**BLAENAU GWENT COUNTY BOROUGH COUNCIL LOCAL
DEVELOPMENT PLAN EXAMINATION**

SESSION 18: MINERALS SITE ALLOCATIONS

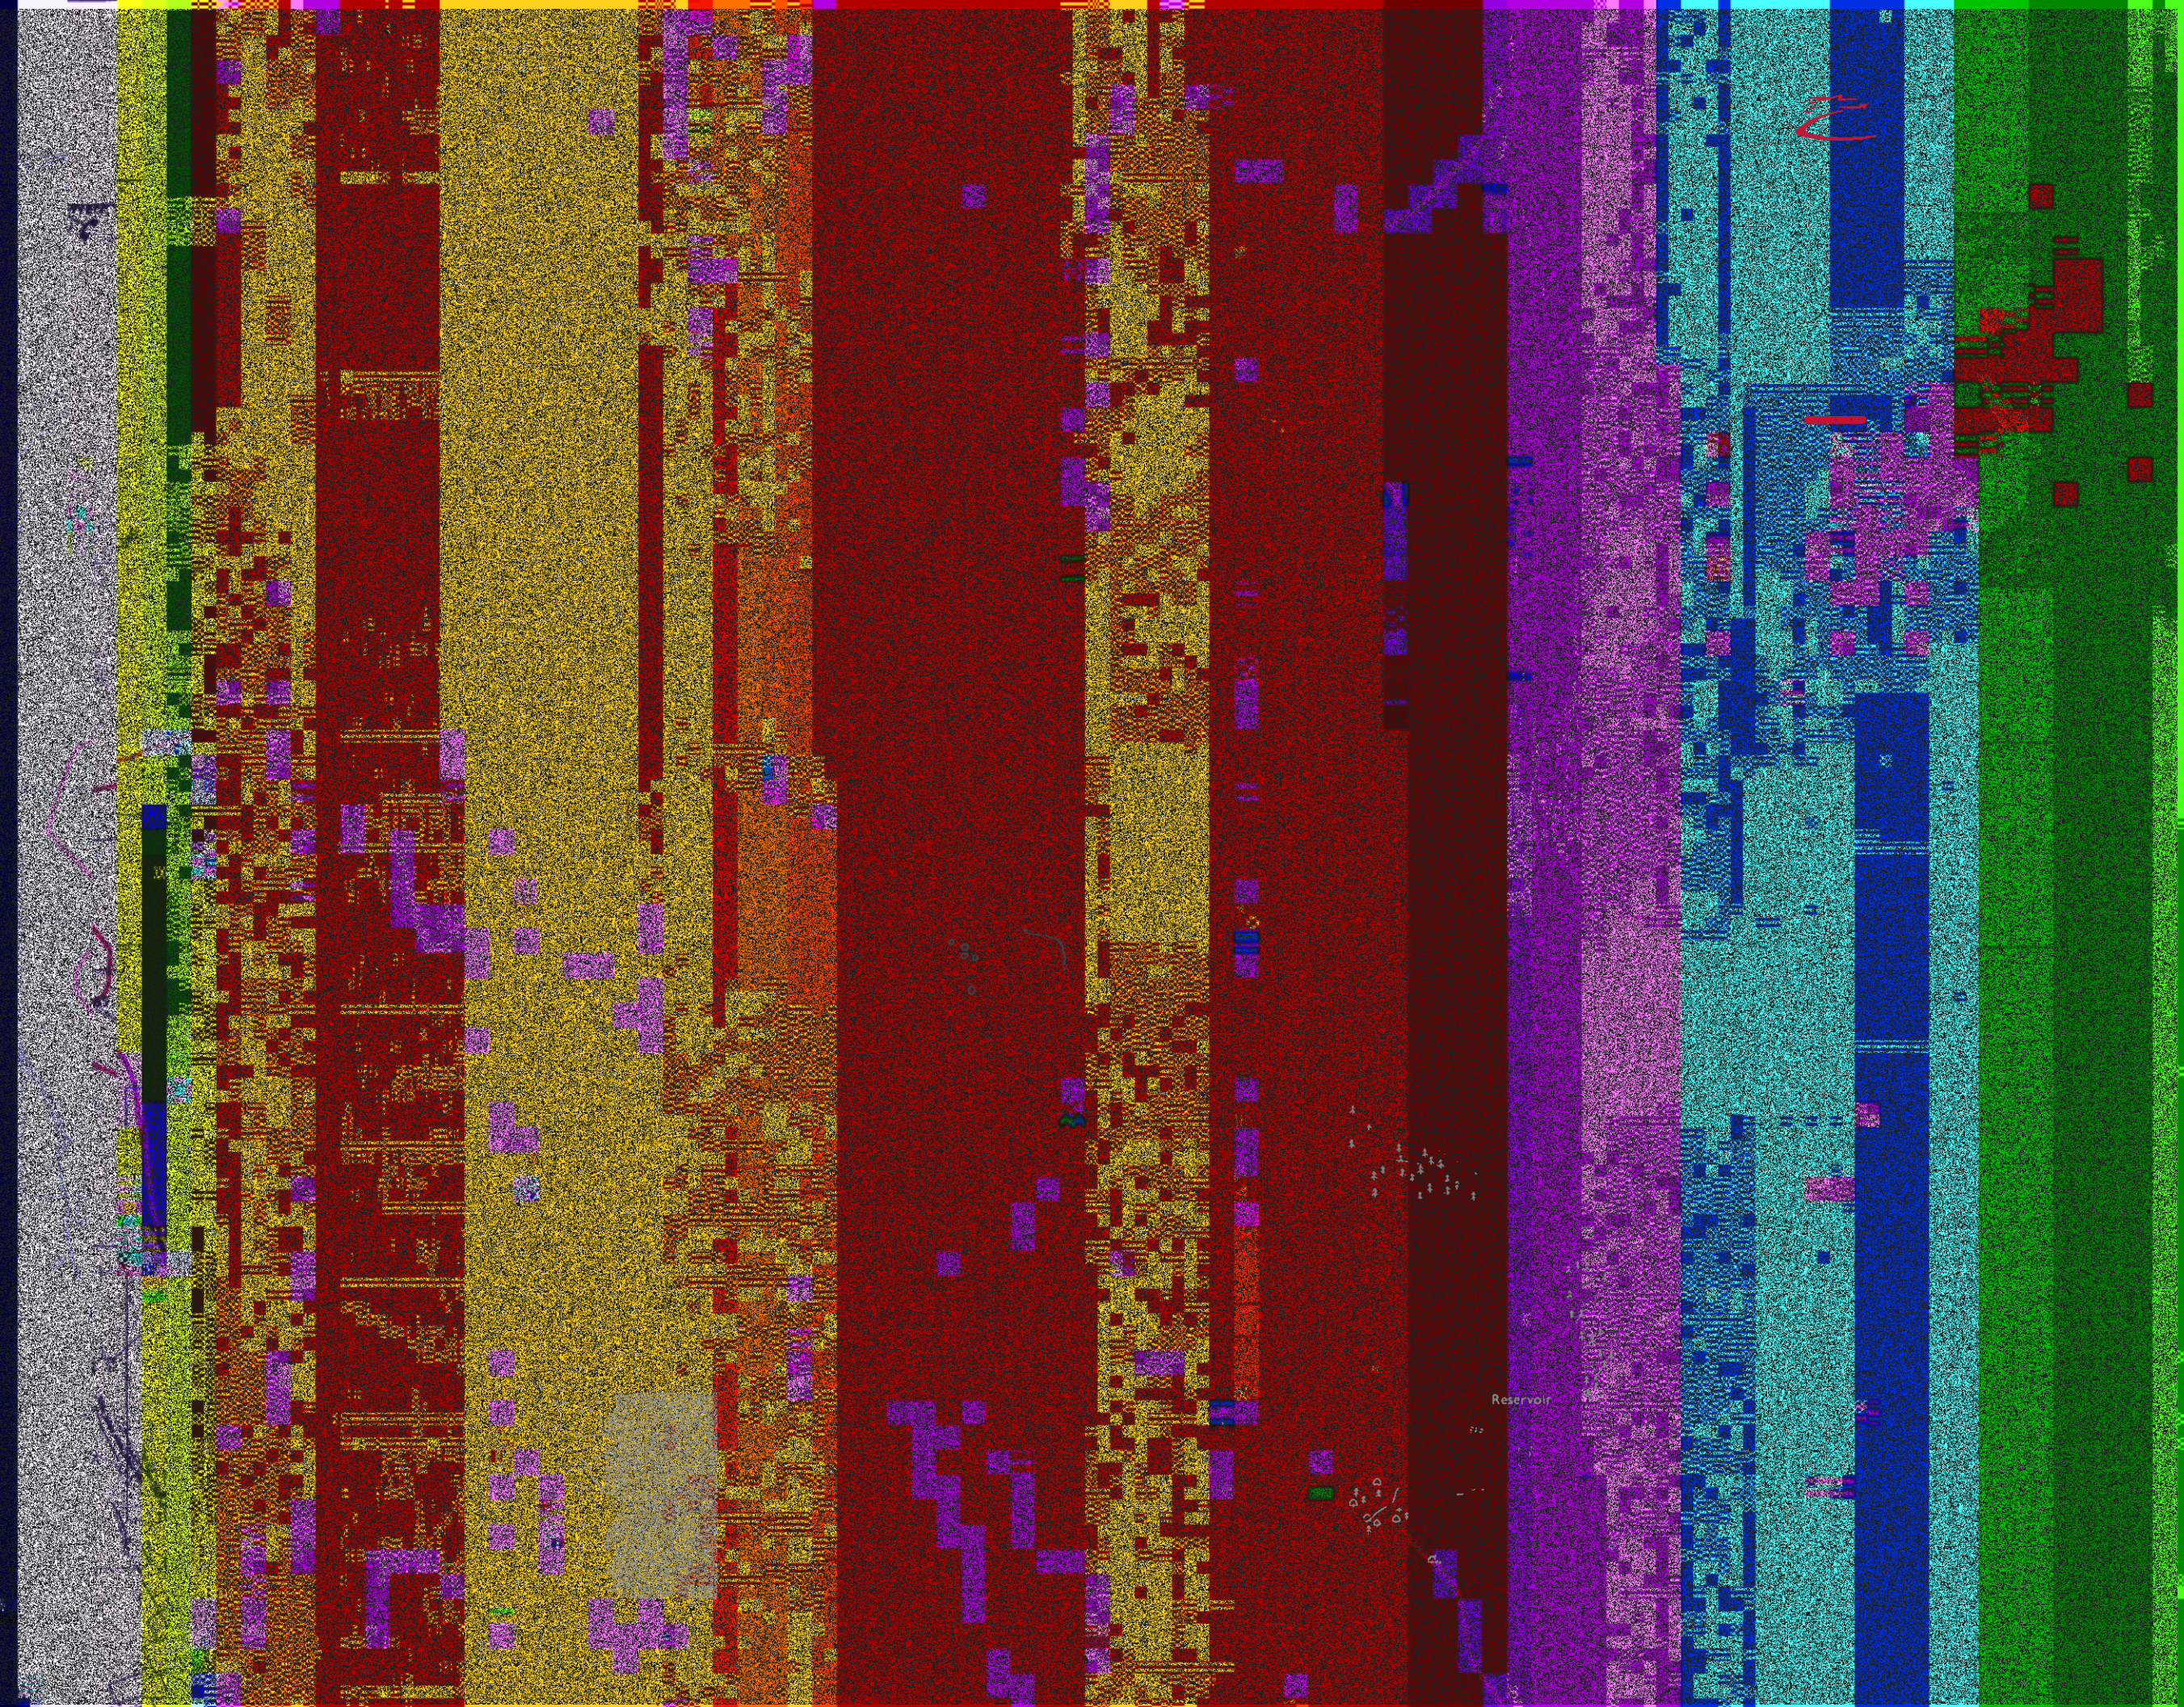
The dolines (both caprock and normal 'solution' dolines) in the allocated site were not fully reflected in the indicative Geological Conservation Review (GCR) boundary that was originally drafted, and following further survey it is now proposed to correct those imbalances by proposing a new GCR/pSSSI boundary that contains all of the interstratal karst interest features that have been identified by the assessment of Mynydd Llangynidr. The indicative boundary drawn in 1982 also included areas with no dolines. These have now been removed from the revised GCR/pSSSI boundary.

The pSSSI includes the land adjacent to Trefil Quarry identified as a preferred area for aggregate extraction in the LDP, Policy M4.1. S

acknowledged importance, contrary to national planning policy, it is not considered that the allocation is soundly based.
